Supplement #3

THE FINAL SUPPLEMENT TO THE
"ENGINEERING EVALUATION OF THE WNP-2
SACRIFICIAL SHIELD WALL" SUBMITTED TO NRC
IN AUGUST 1980

SUMMARY OF WORST CASE DEFECTS IN WELDMENTS

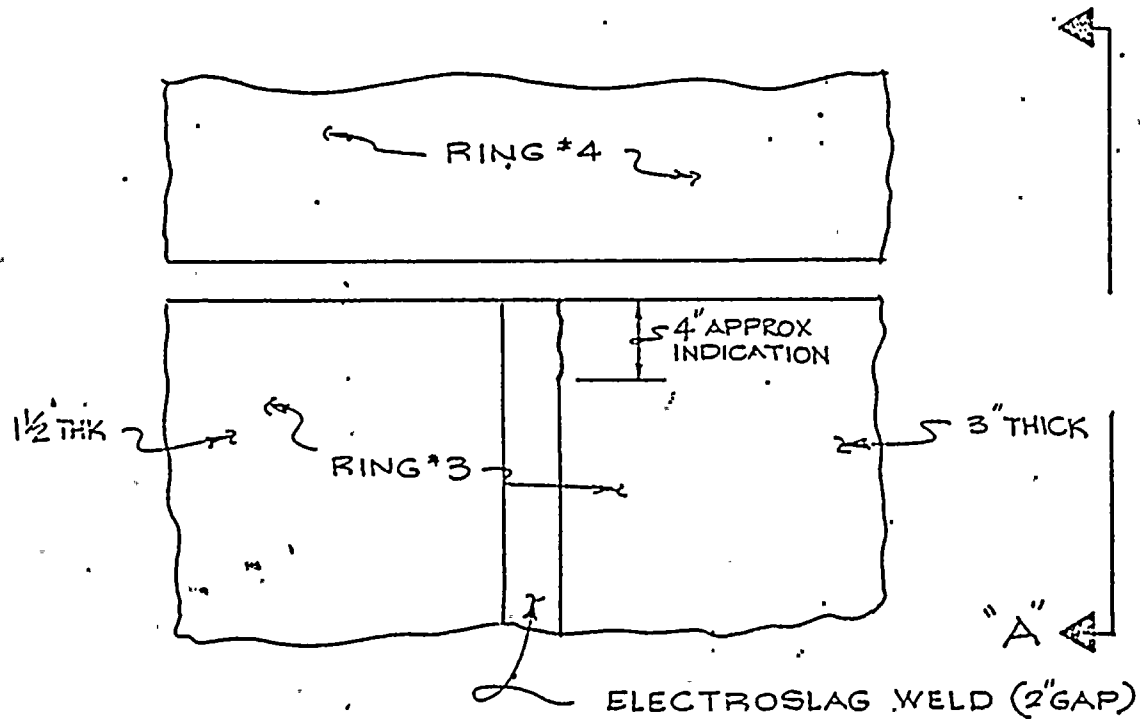
Table III.D.5, attached, is revised, reflecting the 1/4" incomplete penetration, and a corrected typographical error for undercut.

FIG 1. LINEAR INDICATION IN RING 3 AT 135°-150° AZ

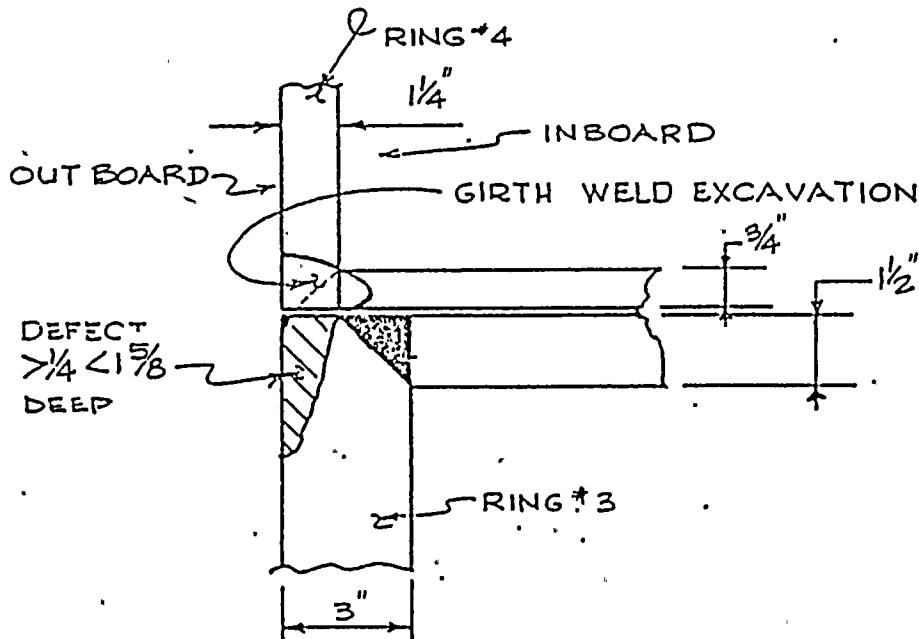
- (i) Linear indications in electrosag welds were discovered adjacent to the girth weld. Details of this deficiency are given in Figures 1 and 2. This deficiency was detected in two of the thirty-two electrosag welds in ring #3 which intersect the girth weld.
- (ii) Linear indications, slag inclusions and porosity were discovered in guide plate welds (see Figure 3).
- (iii) Lack of penetration existed at the weld joint between the bottom flange of ring beam #4 and the exterior web plate. Details of this deficiency are shown in Figure 4. For further discussion and clarification see Part 5.
- (iv) Linear indications in the girth weld excavation probably resulted from the repair of deficiency (iii) above.

These deficiencies are discussed in detail in Ref. 11. It is concluded that the nature and severity of the deficiencies observed during the girth weld repair are bounded by the assumptions of Ref. 1 and that their discovery does not influence the conclusions of Ref. 1 with respect to the integrity of the SSW under design loading conditions.

FIG. 4. LACK OF PENETRATION AT AZ. 90°-105°, 0°-15° AND 180°-195°.

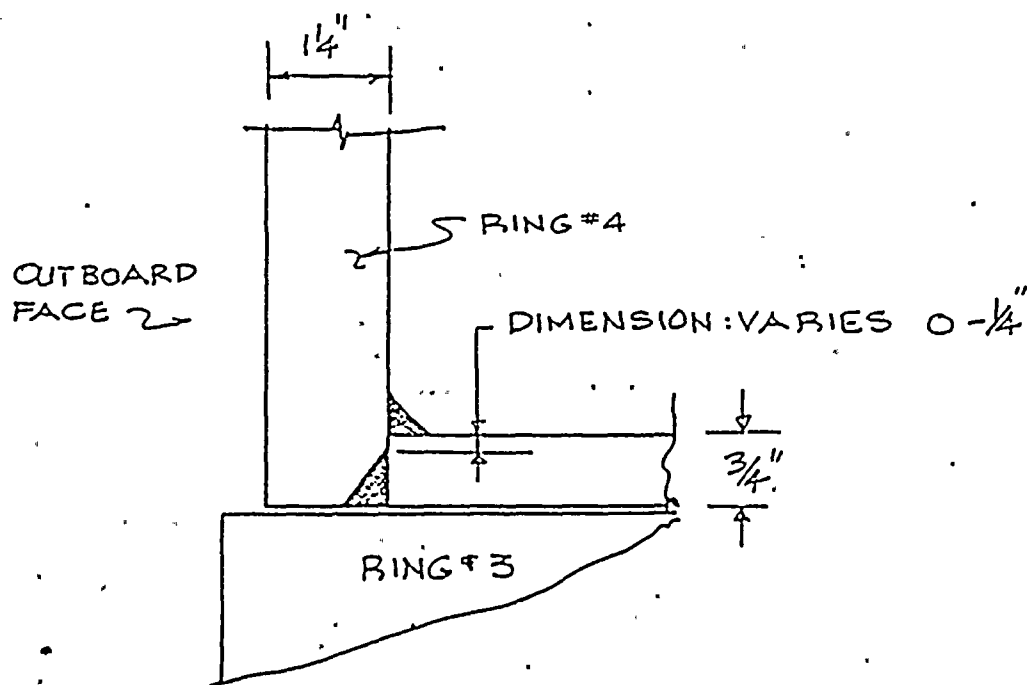
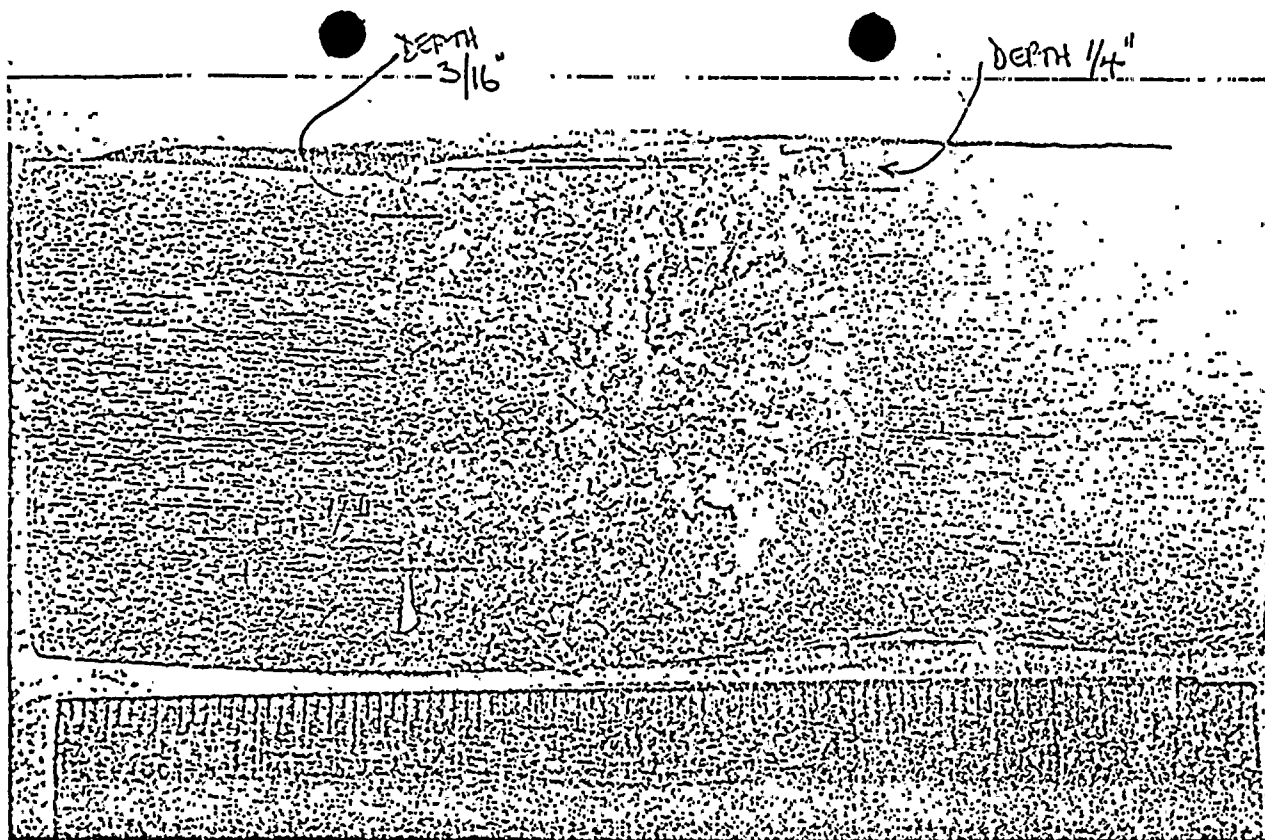
5.1 The Engineering Evaluation of the WNP-2 Sacrificial Shield Wall Supplement No. 2, Part II.C identified three locations where incomplete penetration (I.P.) was discovered in the partial penetration flange-to-web plate weld on ring 4. (See Figure 4 of this supplement). The incomplete penetration identified was 1/4" deep; however, the original report addressed 5/32" as the worst I.P. case in Table III D.5.

In comparing the a/t ratio of 0.33 for the 1/4" I.P. in 3/4" thick material to Table III.D.2, there are no a/t ratios in either the static loading or the dynamic loading columns for any of the materials equal to 0.33. Therefore, plastic collapse will not occur. An a/t ratio greater than 0.5 would have to occur before plastic collapse could occur.

In addition, the potential for plastic collapse is reduced by the design of the SSW. For plastic collapse to occur, large strains and displacements are required. The SSW is a redundant structure in that loads are transmitted through many members in parallel. The displacement which can be applied to a weld joint is limited by parallel joints. The design and the evaluation for plastic collapse leads to the conclusion that the 1/4" I.P. will not cause plastic collapse and is enveloped by the original assessment of the wall.

FIG. 5 TRANSVERSE MACROSECTION THROUGH ELECTROSLAG WELD
RING 224M # 6

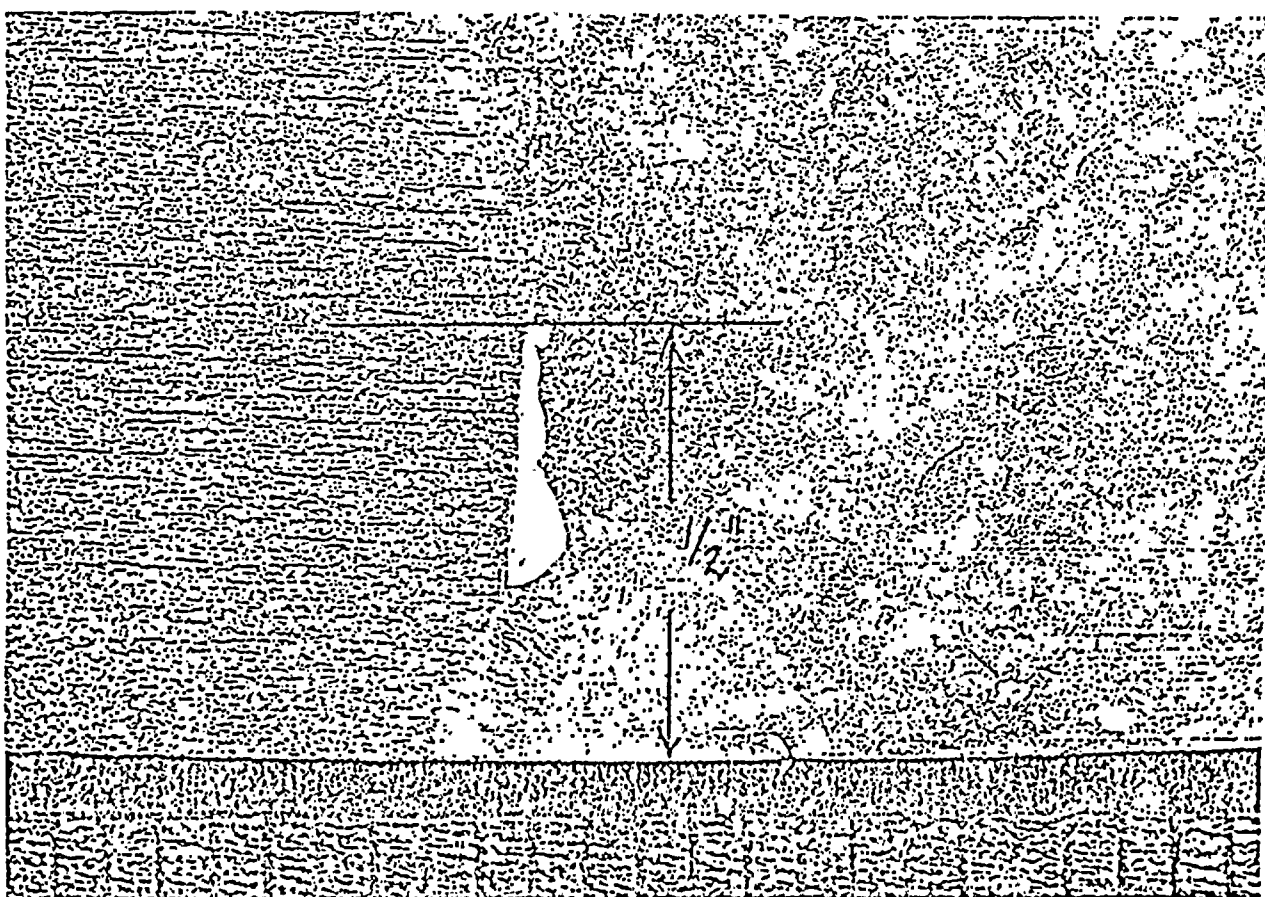
Prior to machining drop weight test plates, the sample was examined by UT and sectioned for macroscopic examination. A subsurface defect was found which extended along the length of the sample. The nature and extent of the defect is shown in Figure 5. It consists of a lack of fusion defect on the sidewall of the weld which originally extended in from the surface of the weld, but was partially excavated and repaired.

In addition, two similar, but shallower defects were observed on the other side of the weld (Figure 5).
